Access Compliance Report

Public Rights-of-Way

(Curb Ramps)

Intersection ID: 10034399	Main Street: PIEDMONT_PARK_DR	Cross Street: AUDUBON_PARK_DR	Location: S
ADA ID: 0E957972E5BD	Ramp Type: Directional1	Initial Pass/Fail: Fail	Overall Compliance: No
Severity Score: 1.25			
Codes/Mitigation Info/Possible Solution		Field Measurements/Component Compliance

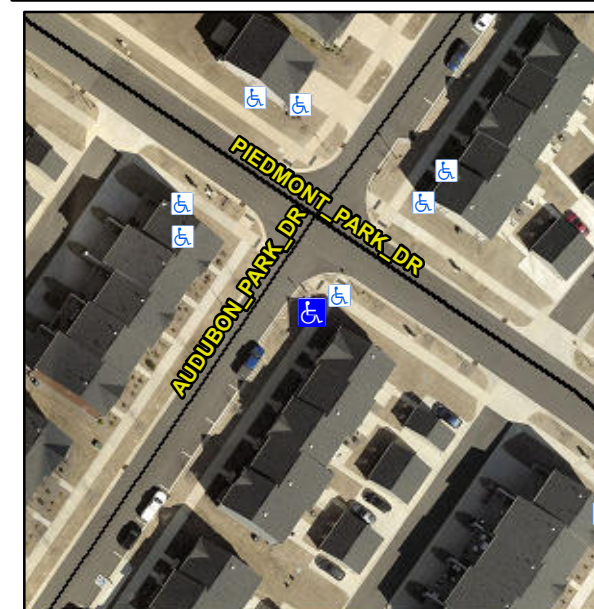
Possible Solutions:

Remove & Replace Entire Ramp.

PROW/ADA:

R304.5.3

Compliance	Description	Data	Compliance	Description	Data
N/A	Ramp Length (in)	79.0	N/A	Grade Break?	N/A
Yes	Ramp Width (in)	69.0	N/A	Grade Break Slope (%)	0.0
Yes	Ramp Slope (%)	6.6	N/A	Grade Break XSlope (%)	0.0
No	Ramp XSlope (%)	3.4			
N/A	Flare Type LT	N/A	N/A	Flare Type RT	N/A
N/A	Flare Slope LT (%)	N/A	N/A	Flare Slope RT (%)	0.0
N/A	Flare Traversable LT?	N/A	N/A	Flare Traversable RT?	N/A
N/A	Landing Length (in)	0.0	N/A	DWS Provided?	N/A
N/A	Landing Width (in)	0.0	N/A	DWS Contrast?	N/A
N/A	Landing Slope (%)	0.0	N/A	DWS Length (in)	N/A
N/A	Landing X Slope (%)	0.0	N/A	DWS Full Width?	N/A
N/A	Landing Curb? (Y/N)	N/A	N/A	DWS Offset LT (in)	N/A
N/A	Shared Landing?	N/A	N/A	DWS Offset RT (in)	N/A
N/A	Gutter Ponding?	0.0	N/A	Gutter Slope (%)	N/A
N/A	Gutter Lip Ht (in)	0.0	N/A	Gutter X Slope (%)	N/A
N/A	Painted X Walk1?	No		Road Slope (%)	5.8
	X Walk 1 Direction	To NW		Road X Slope (%)	3.4
	X Walk 1 Width (in)	N/A		Clear Space?	N/A
